Zion Nuclear Power Station, Units 1, 2 and ISFSI
Facility Operating License Nos. DPR-39 and DPR-48
NRC Docket Nos. 50-295, 50-304 and 72-1037

Subject: Radioactive Effluent Release Report, Radioactive Effluent Control Program Report, Offsite Dose Calculation Manual and Process Control Program for 2015

1. Radioactive Effluent Release Report
2. ECN# 400577 Extending liquid effluent discharge line through the discharge tunnel
3. ECN# 400657 Installing additional liquid effluent discharge flowmeters
4. ECN# 400986 Increased capacity dilution water pump of 10,000 gpm and associated flowmeters
5. ECN# 2015-04 Installation of new liquid effluent radiation monitor for 0RT-PR04 and dilution flow permissive for lake discharge valve 0SOV-WD010
6. Current Copy of Zion Station ODCM, Rev. 5

ECN 400577 TP
PART 4
Page 7 of 12
M-101 Mark Up for installation clarity
Prepared by: Lee DeBus Date: 1-26-15
Reviewed By: L.S. Langdon Date: 01/26/2015

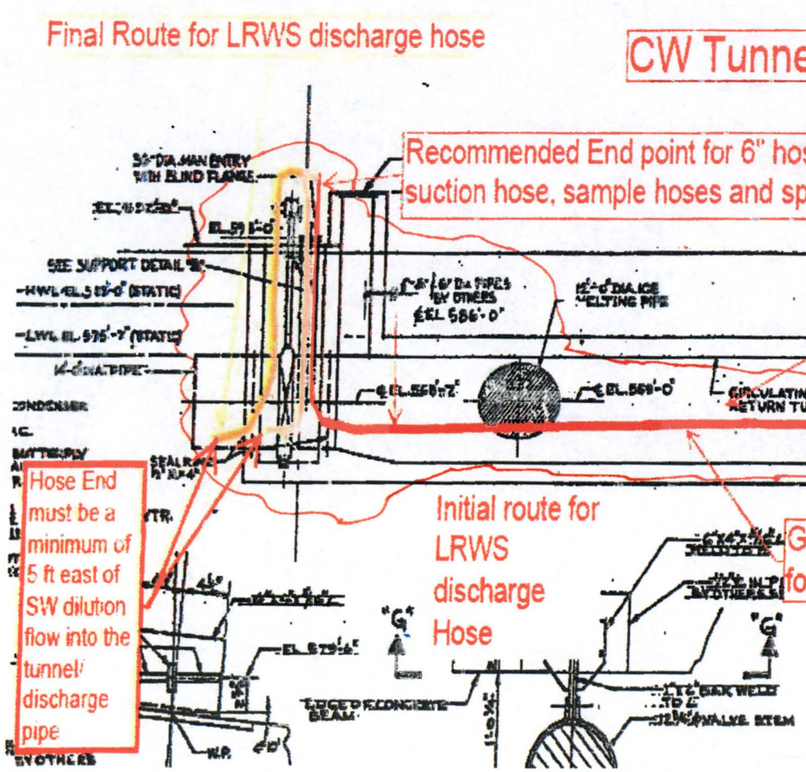
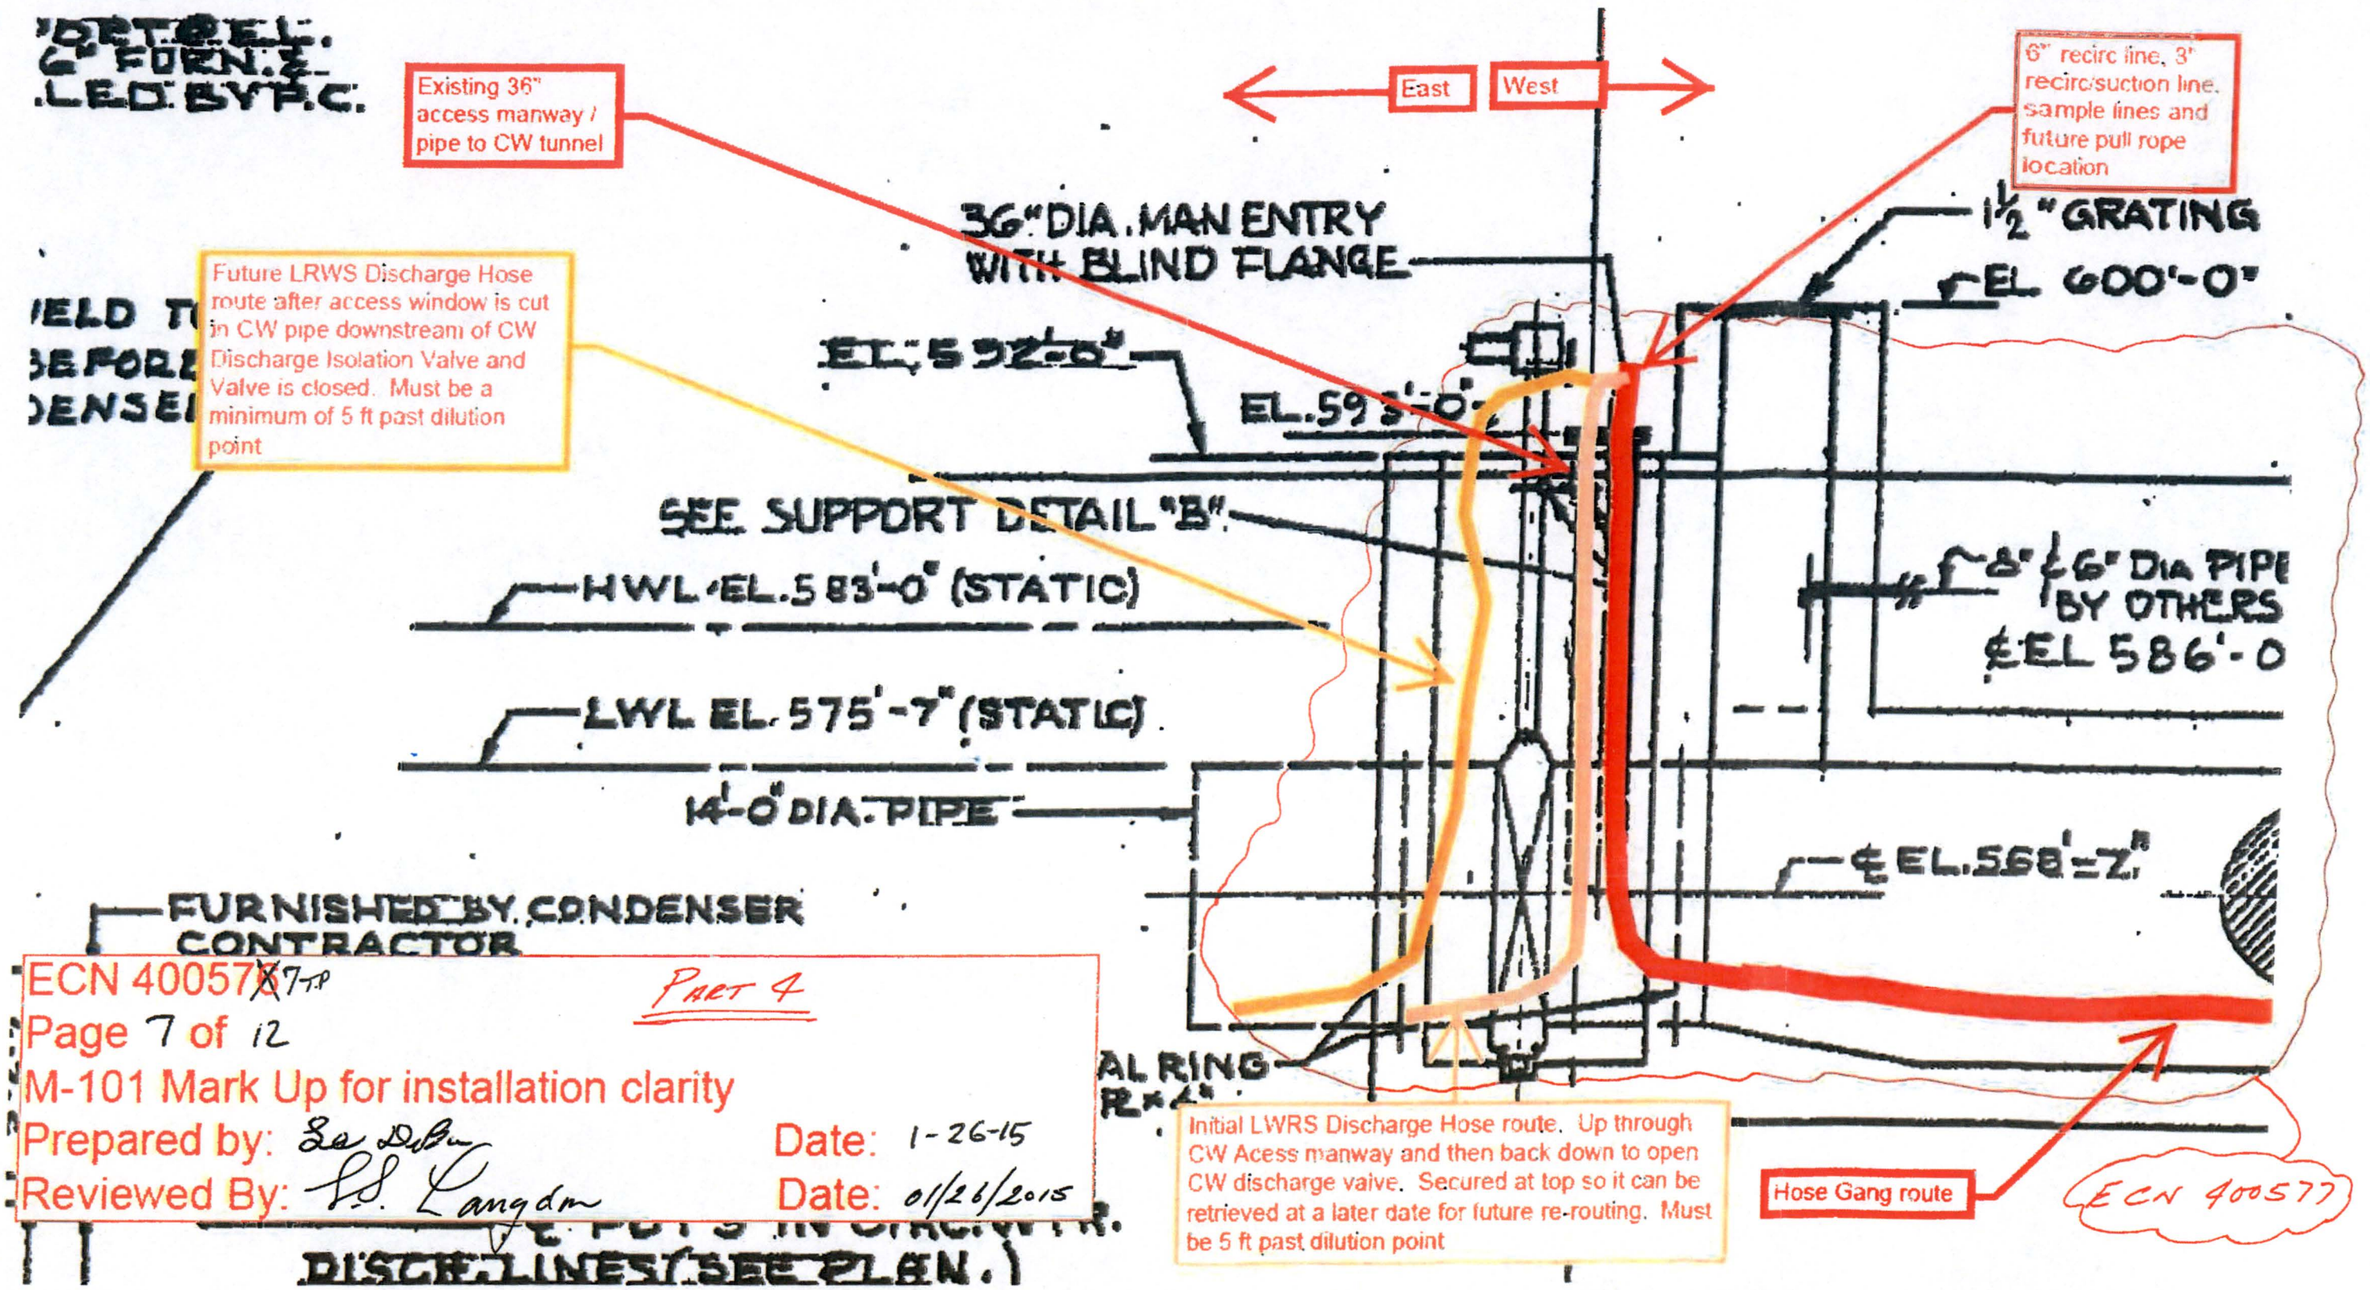
SECTION 'B-B'
SIMILAR FOR UNIT-2

Hose gang may be pulled on either side of tunnel support in this area Ref B-100

Recommended approximate End Point for 6" recirc hose and 3" recirc/suctoin hose

ECN 400577
Page 11 of 12
M-49 Sht 1 Mark Up
Prepared By Lee D/B Date 1-26-15
Reviewed By L.S. Langdon Date 01/26/2015

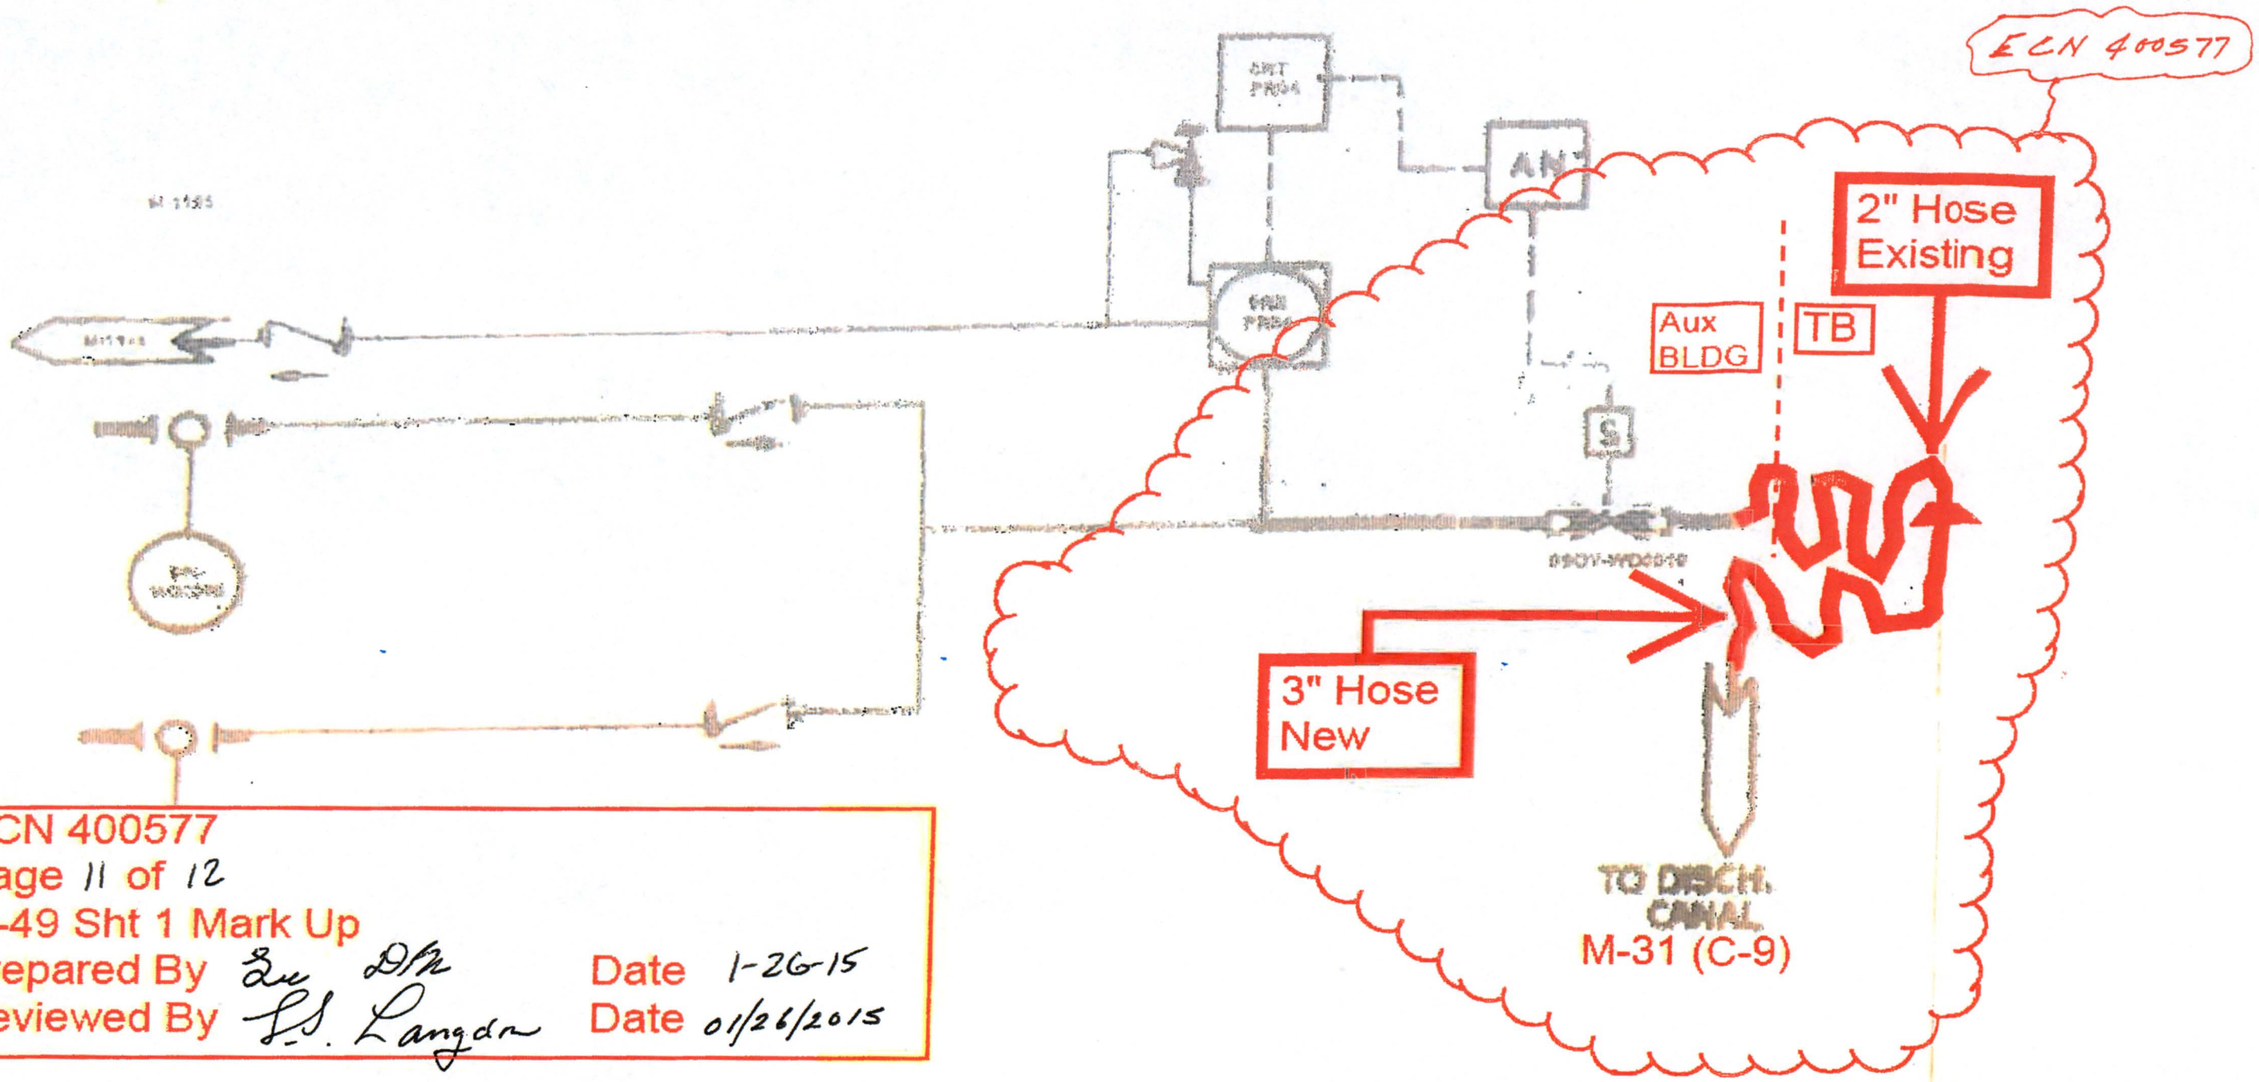
3" Hose from LRWS M-49 Sht. 1 (E-10)

Photo 2

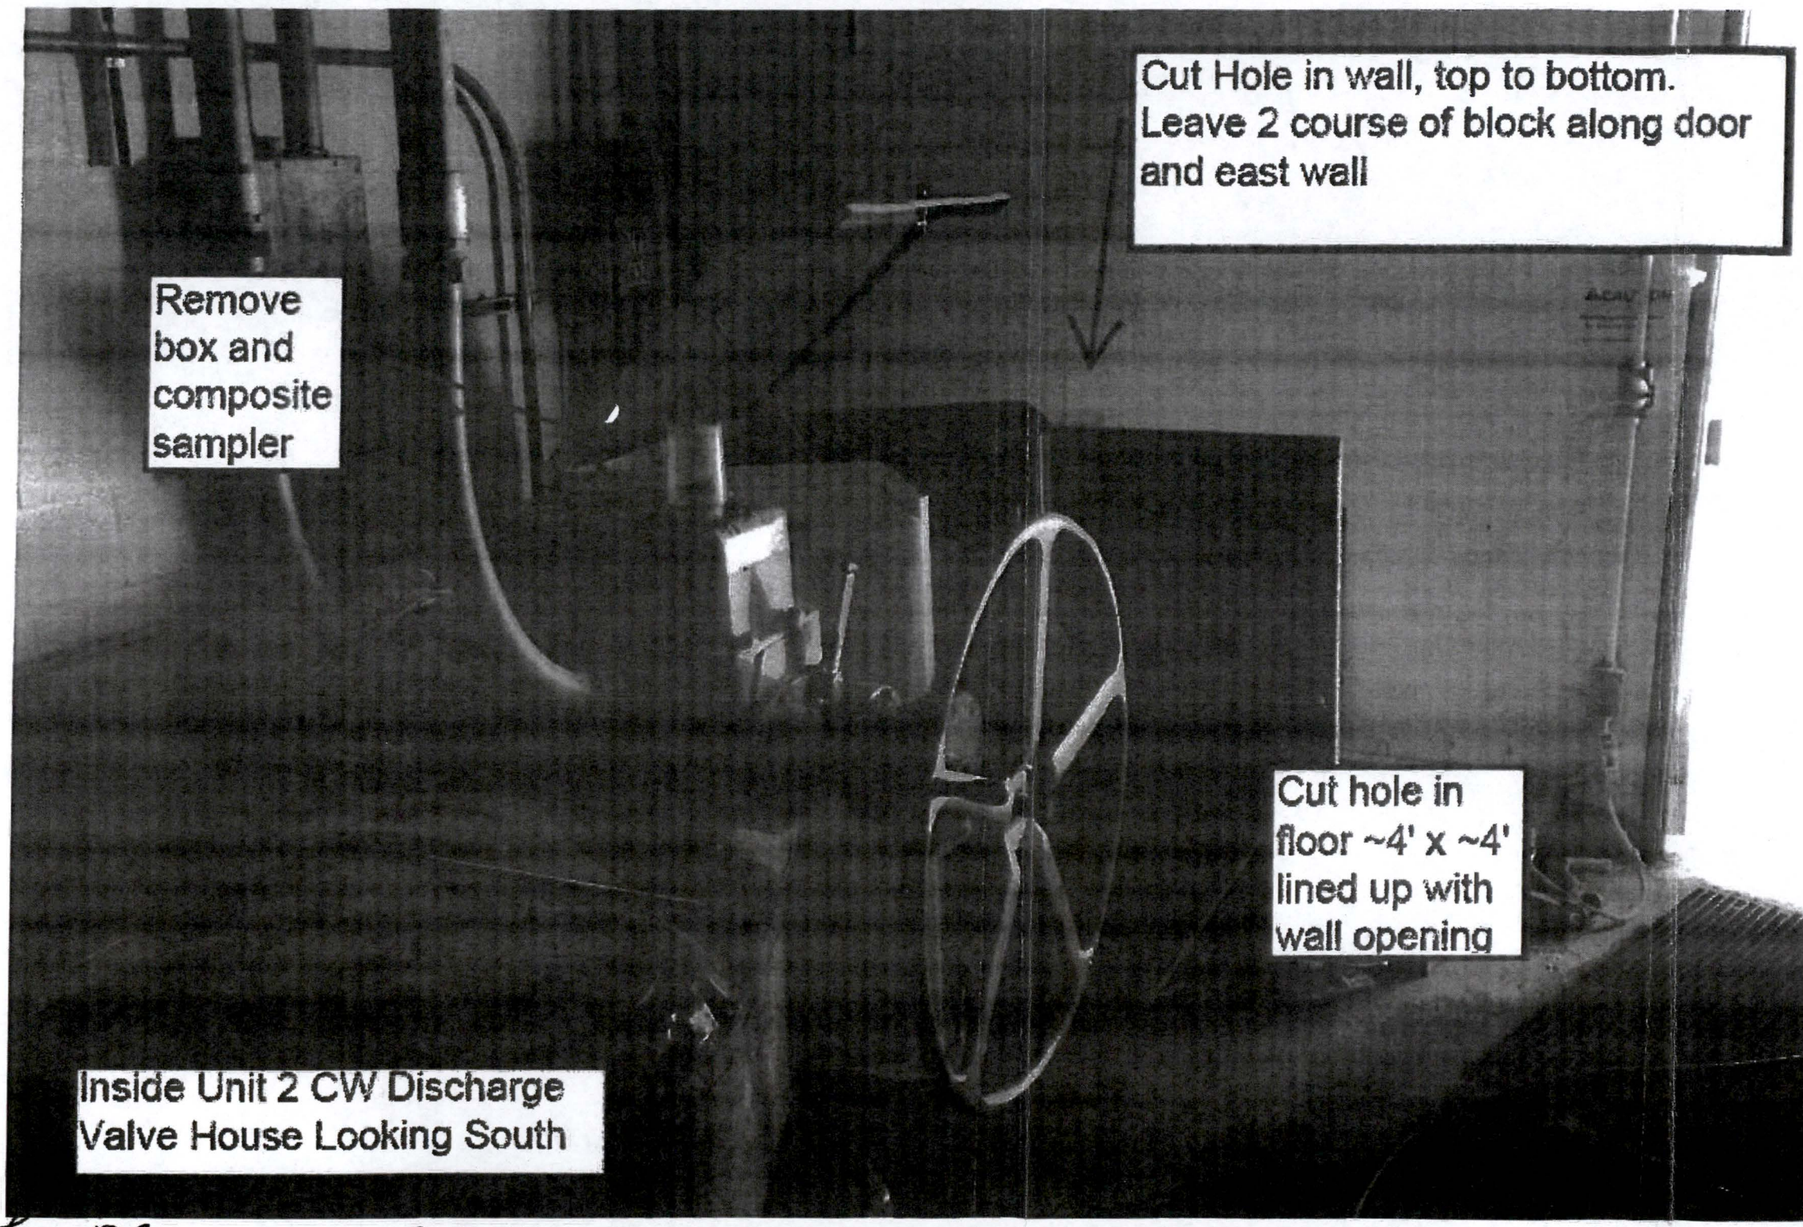
1. Verify Section 1 capping of Unit 2 Oil Separator Inputs are complete.
2. Remove Unit 2 Oil Separator Composite Sampler. Cut back electrical cables, sample lines, supports and heat trace as required clearing the area for a hole in the floor. See Photo 2 and Electrical ECN 400987.
3. Verify relocated electrical box on south wall to west wall per ECN 400987. See Photo 3 of this ECN.
4. Remove abandon materials (conduits, cables, cameras, etc) as required in preparation to remove a portion of the south wall. See Photo 2, 4 and 6.

Photo 7

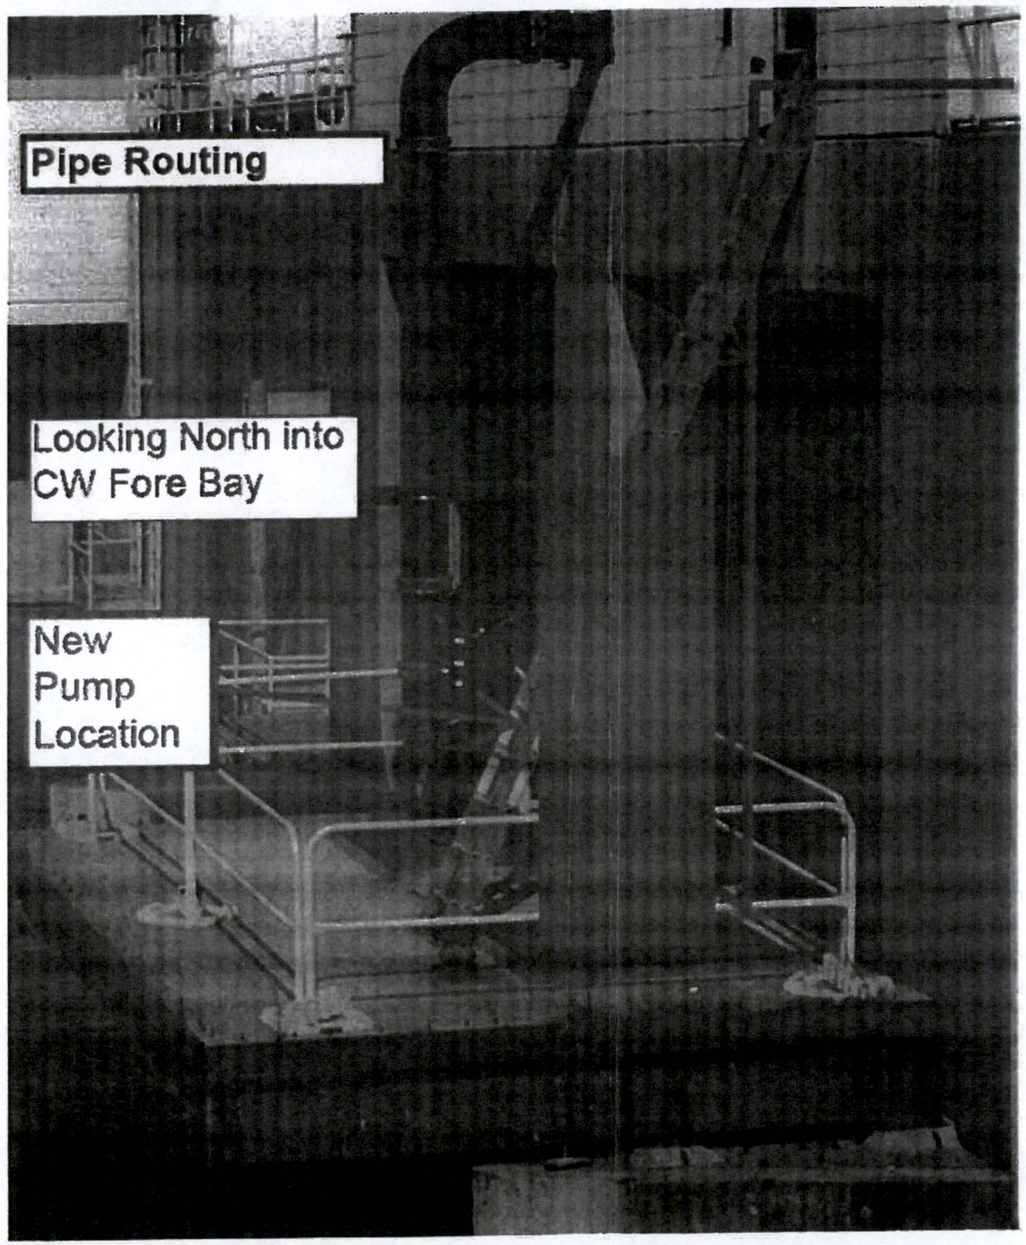
10. Install flexible boot to pump per Sketch 4A, photo 7.
11. Install riser pipe per Sketches 4A, 4B and Pipe Fabrication Vendor drawing and instructions. (Engineering to review and approve vendor drawings and instructions)
12. Install pipe anchor per Sketches 5, 6 and 7.
